**ATTACHMENT A**  
**BLM COMMENT RESPONSES**  
**WITH EXTENDED NARRATIVES**  
**MARCH 31, 2017**

**BLM GENERAL 5**

**Figure 5-55**  
**Kanab Creek near Kanab, Daily Flows**

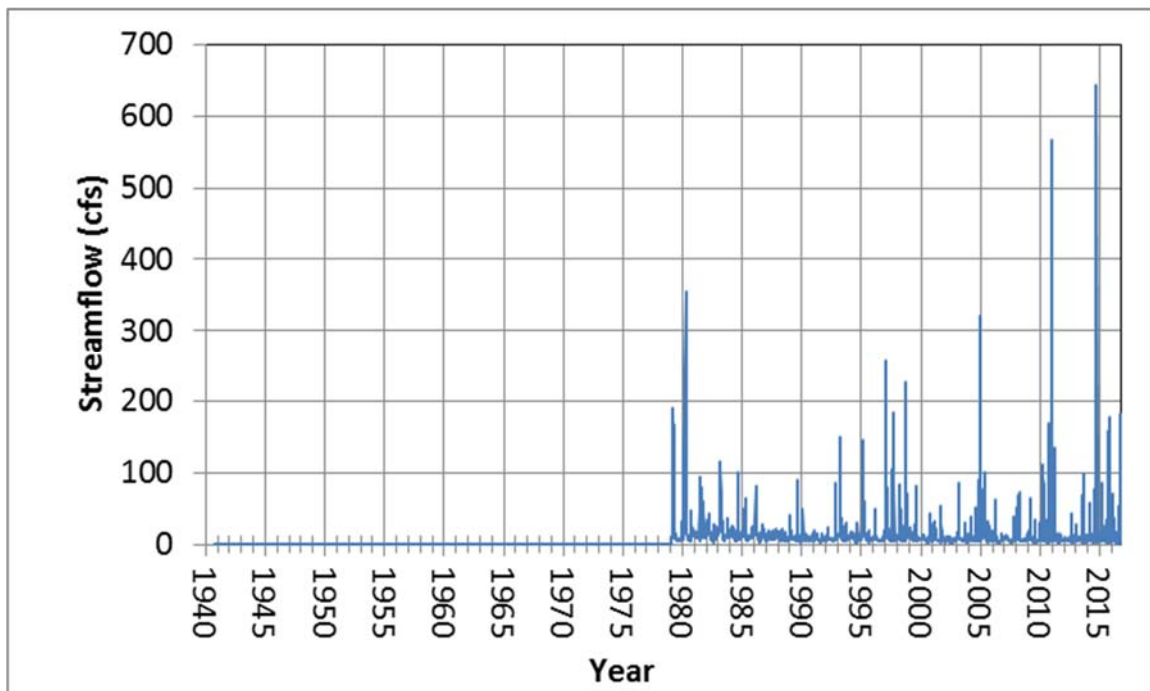
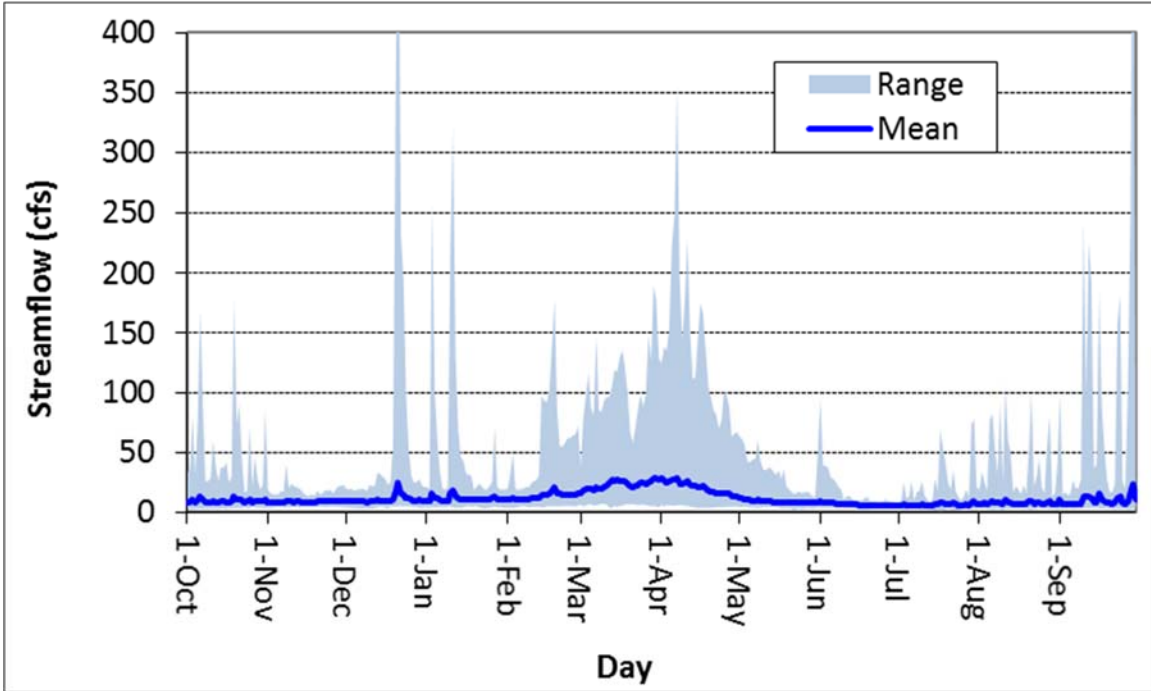
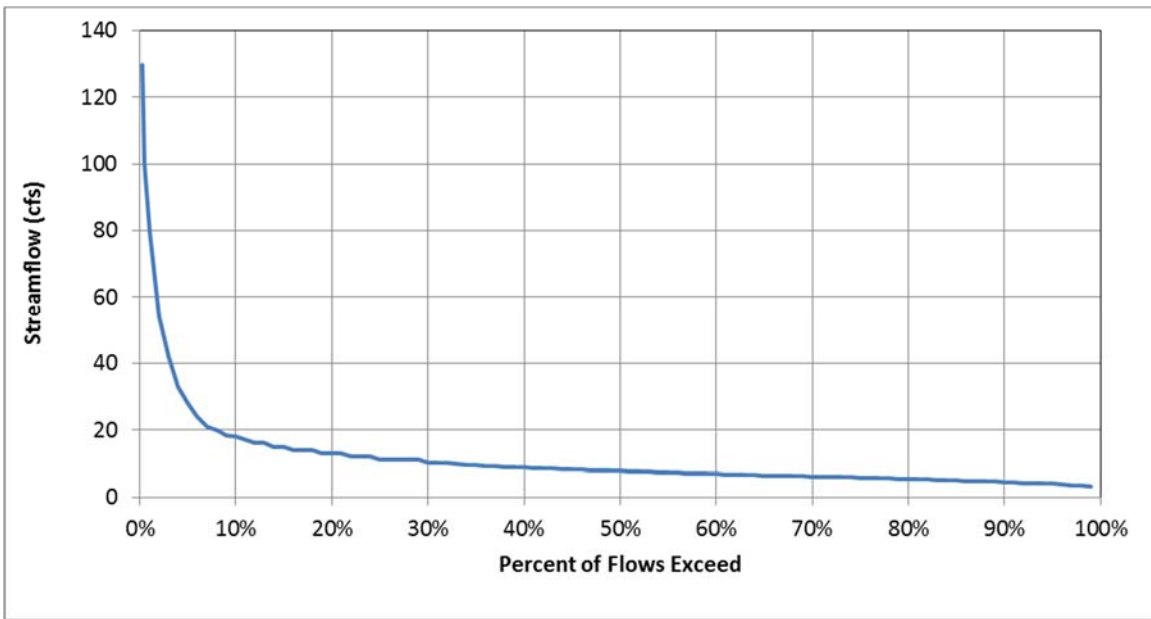
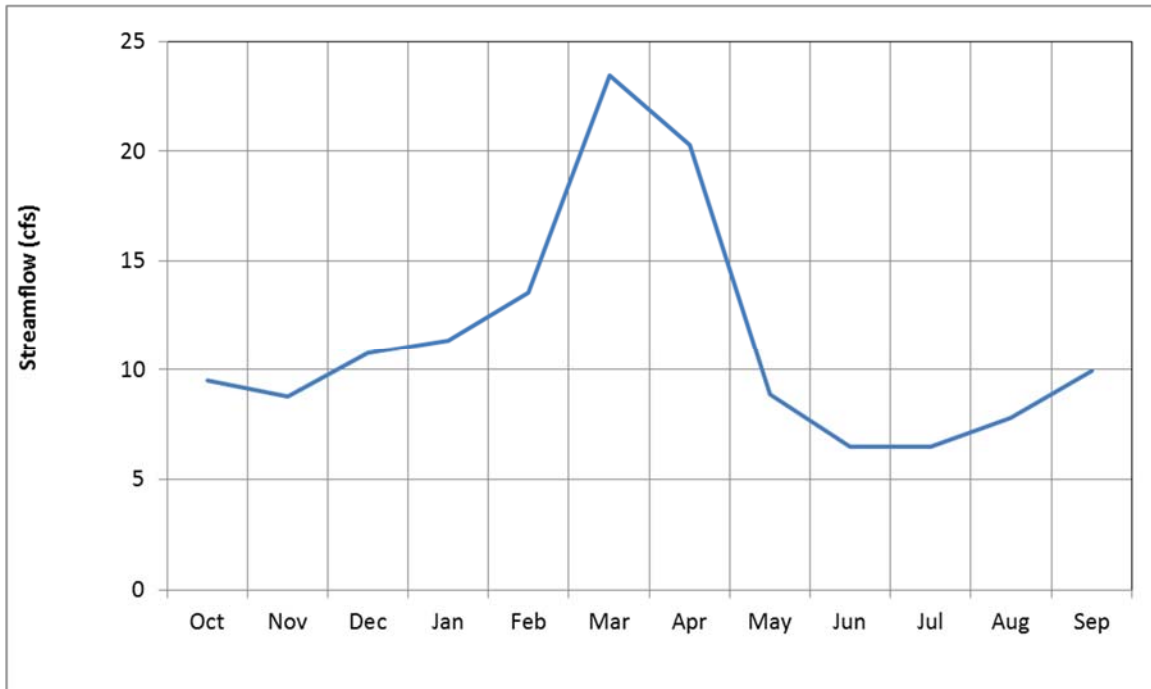
**BLM 609**

The Final License Application filed with FERC shows the figure in BLM Comment No. 609 as Figure 5-55. The updated Figure 5-55 displaying Mean Daily Flows for Kanab Creek near Kanab for the period 1940 through September 30, 2016 is shown below. Figure 5-56 in the Final License Application is changed as a result of the updated data shown in Figure 5-55. The updated Figure 5-56 is shown below.

Figure 5-57 in the Final License Application is changed as a result of the updated data shown in Figure 5-55. The updated Figure 5-57 displaying the flow exceedance curve for Kanab Creek near Kanab for the period 1940 through 2016 is shown below. The text referencing the reader to Figure 5-57 is revised to read as follows: **Figure 5-57 depicts the flow exceedance curve. The 90 percent exceedance value is 5 cfs while the 10 percent exceedance value is 18 cfs. The median flow is 8 cfs.**

Figure 5-58 in the Final License Application is changed as a result of the updated data shown in Figure 5-55. The text referencing the reader to Figure 5-58 is changed to read as follows: **Figure 5-58 shows monthly mean flows for the Kanab Creek near Kanab, Utah gage for the period of 1940 through 2016. Peak flows occur in the spring with low flows occurring in the summer.** The updated Figure 5-58 displaying Monthly Mean Flows for Kanab Creek near Kanab for the period 1940 through 2016 is shown below.

**Figure 5-59**  
**Kanab Creek near Kanab Annual Mean Flows**

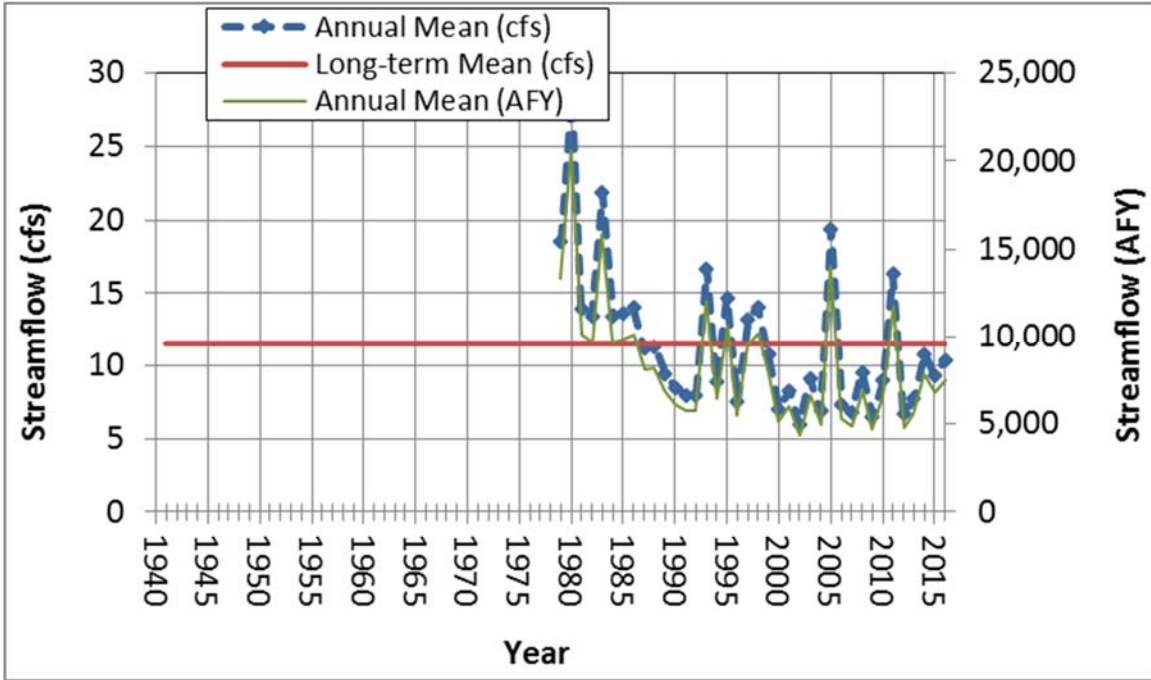
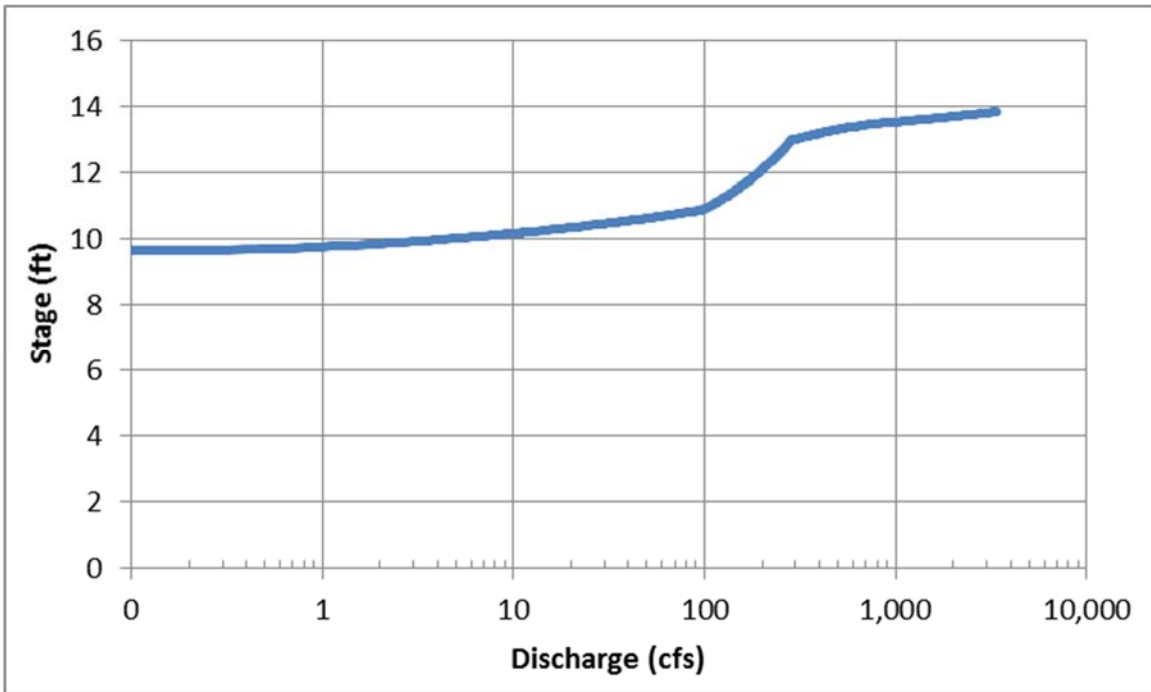
### **BLM 611**

The Final License Application filed with FERC shows the figure in BLM Comment No. 611 as Figure 5-59. The text referencing the reader to Figure 5-59 is changed to read as follows: **The long term annual mean streamflow is 11 cfs.** The updated Figure 5-59 displaying Kanab Creek near Kanab, Annual Mean Flows through 2016 is shown below. The last data points on the graph represent the annual mean flow for the period January 1, 2016 through December 31, 2016. Figure 5-60 in the Final License Application is changed as a result of the updated data shown in Figure 5-59. The updated Figure 5-60 is shown below.

**Figure 5-61**  
**Paria River near Kanab, Daily Flows**

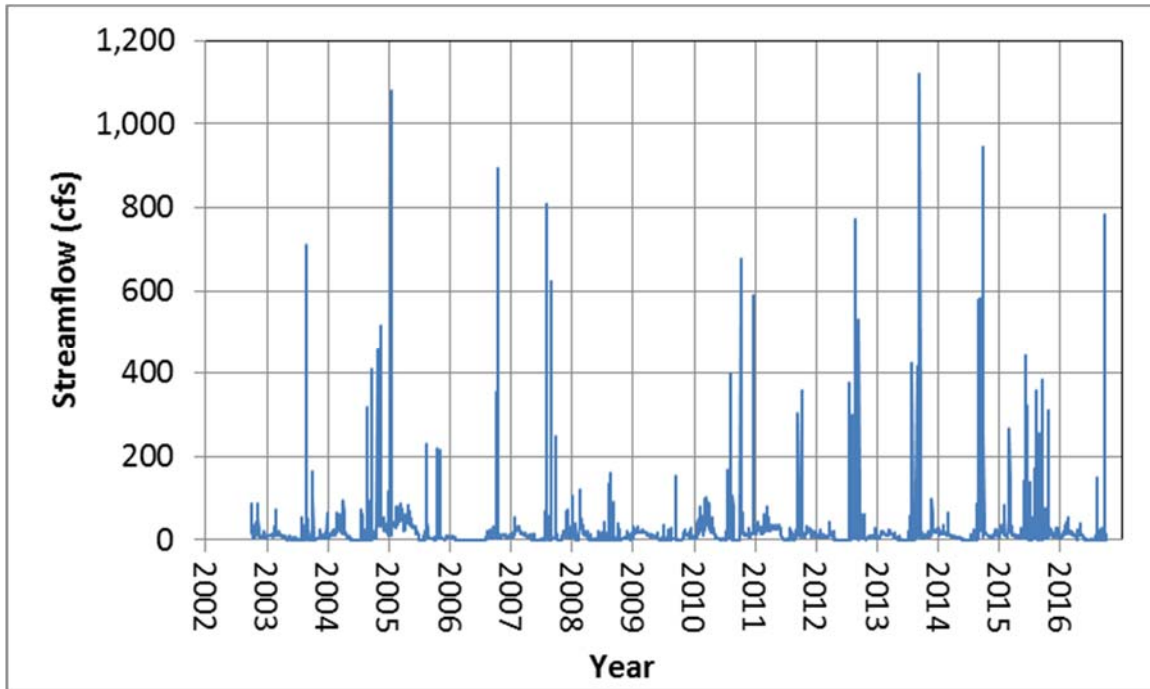
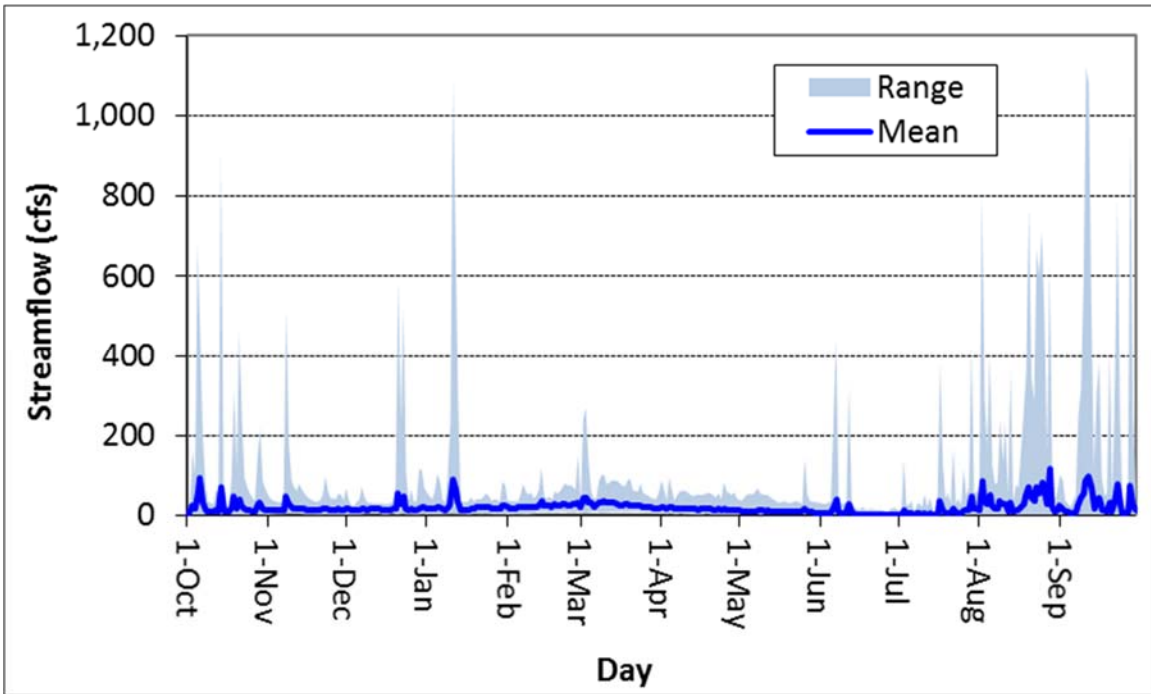
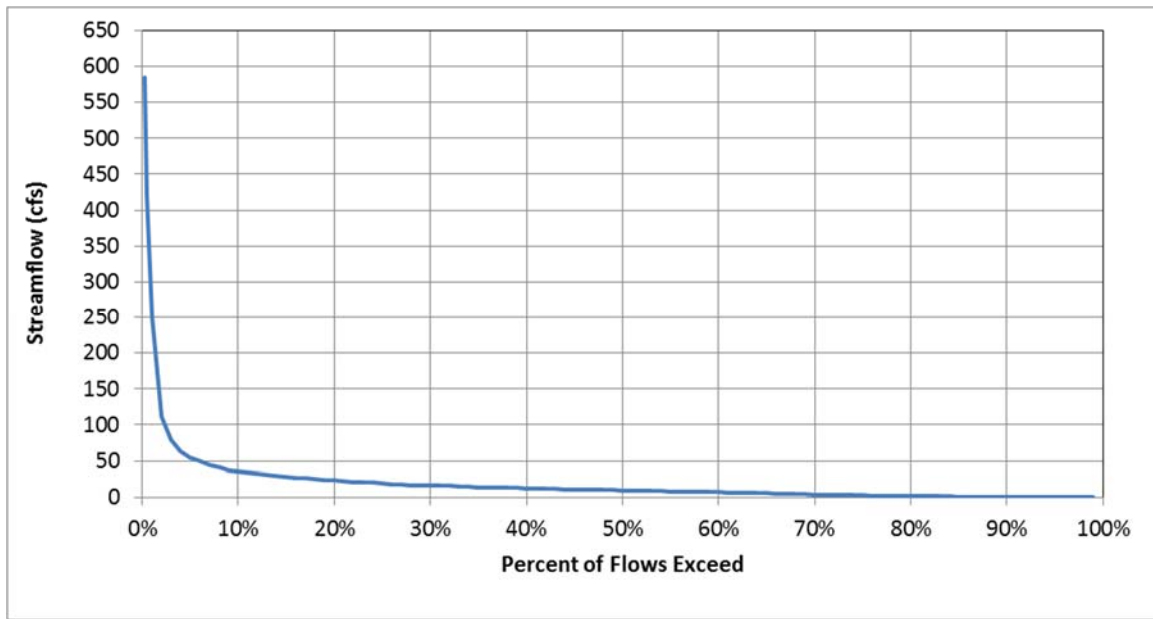
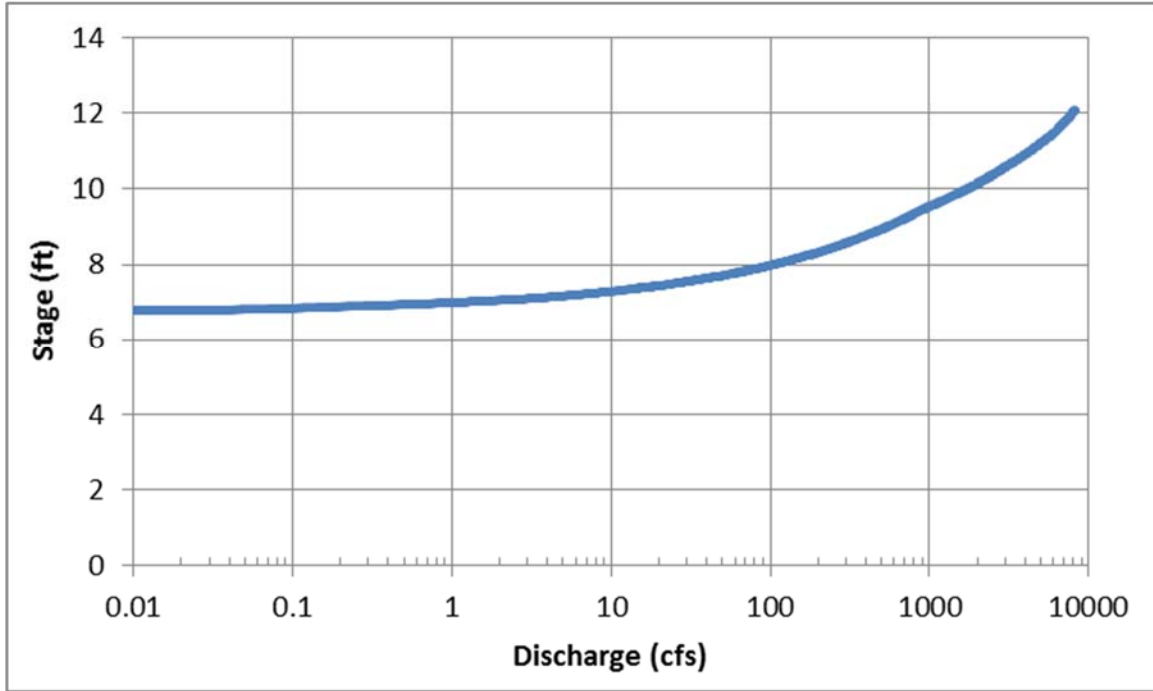
**BLM 612**

The Final License Application filed with FERC shows the figure in BLM Comment No. 612 as Figure 5-61. The updated Figure 5-61 displaying Mean Daily Flows for the Paria River near Kanab for the period 2002 through September 30, 2016 is shown below. Figure 5-62 in the Final License Application is changed as a result of the updated data shown in Figure 5-61. The updated Figure 5-62 is shown below.

Figure 5-63 in the Final License Application is changed as a result of the updated data shown in Figure 5-61. The updated Figure 5-63 displaying the flow exceedance curve for the Paria River near Kanab for the period 2002 through 2016 is shown below. The text referencing the reader to Figure 5-63 is changed to read as follows: **Figure 5-63 depicts the flow exceedance curve. The 90 percent exceedance value is 0.2 cfs while the 10 percent exceedance value is 36 cfs. The median flow is 9 cfs.**

Figure 5-64 in the Final License Application is changed as a result of the updated data shown in Figure 5-61. The updated Figure 5-64 is shown below.

**Figure 5-65**  
**St. George Wastewater Plant Historical Effluent Flows**

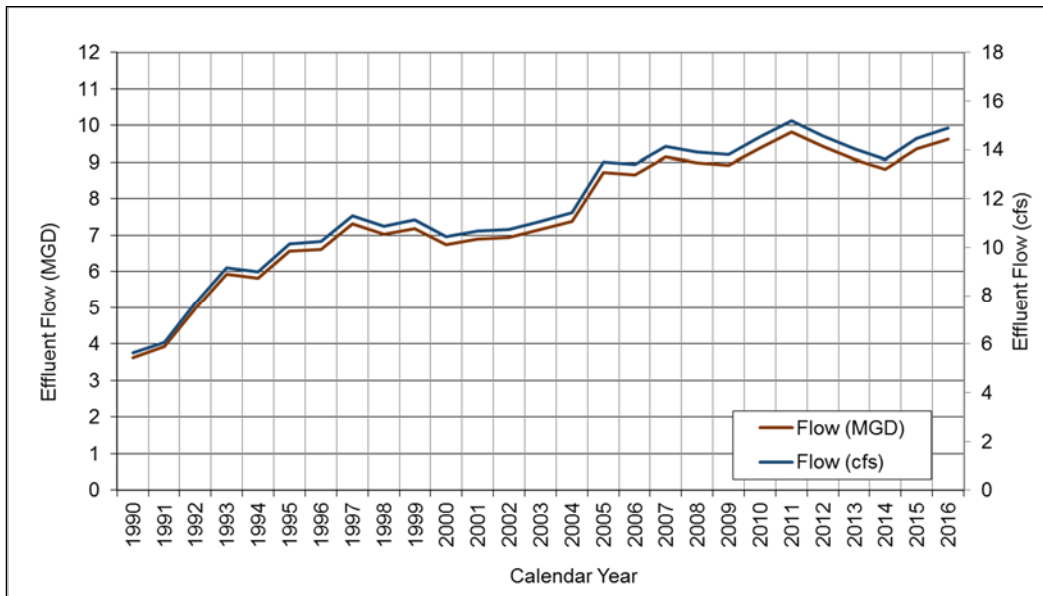
**BLM 615**

The Final License Application filed with FERC shows the figure in BLM Comment No. 615 as Figure 5-65. The updated Figure 5-65 displaying the historical effluent flows for the St. George Wastewater Treatment Plant for the period 1990 through 2016 is shown below.

**Figure 5-67**  
**Lake Powell Historical Storage**

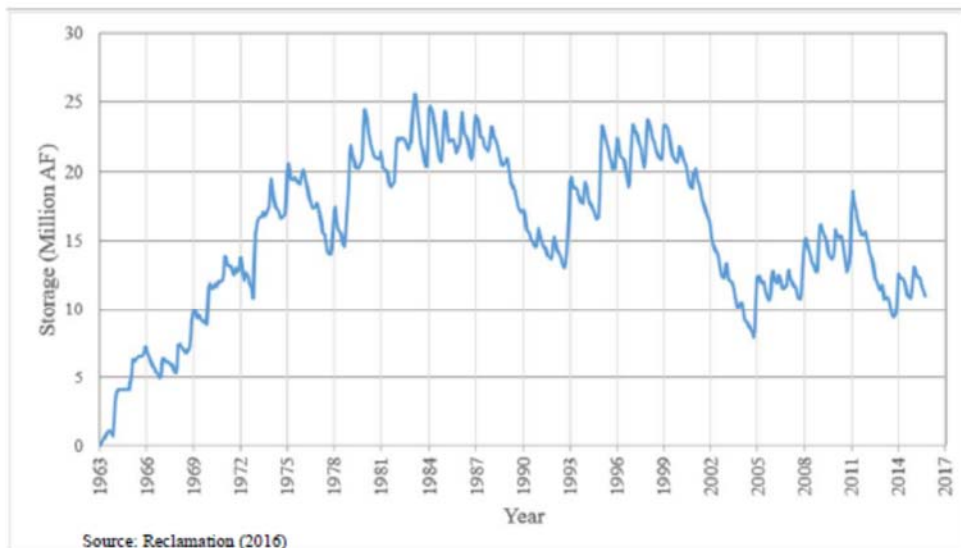
### **BLM 619**

Figure 5-67 in Chapter 5, Exhibit E of the License Application filed with FERC is shown below:

**Figure 5-68  
Lake Powell Historical Stage**

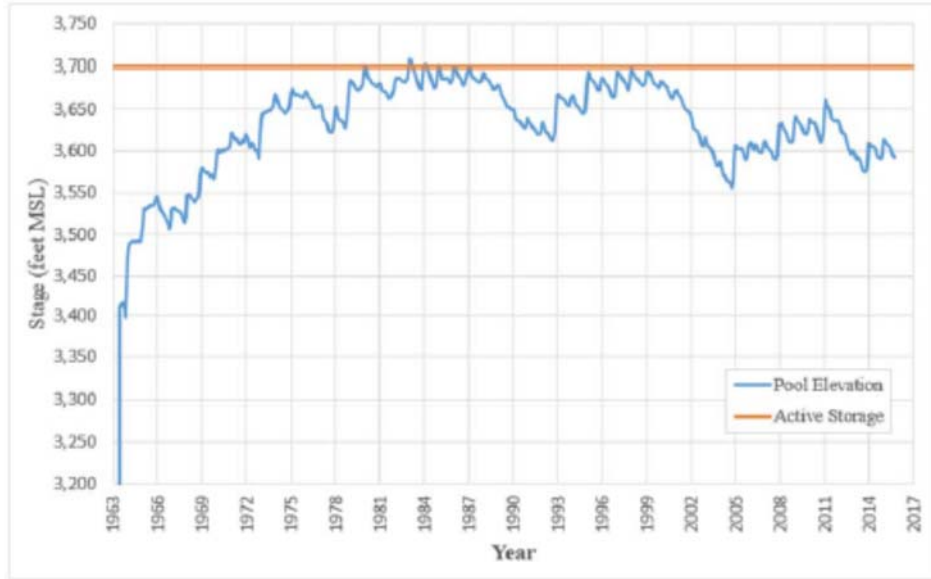
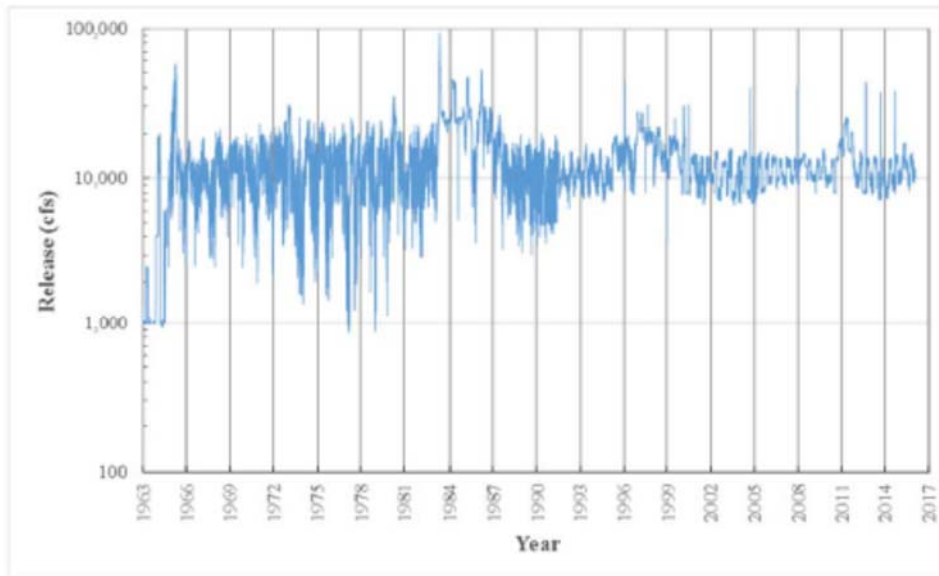
**BLM 620 AND BLM 621**

Figures 5-68 and 5-69 in Chapter 5, Exhibit E of the License Application filed with FERC are shown below:
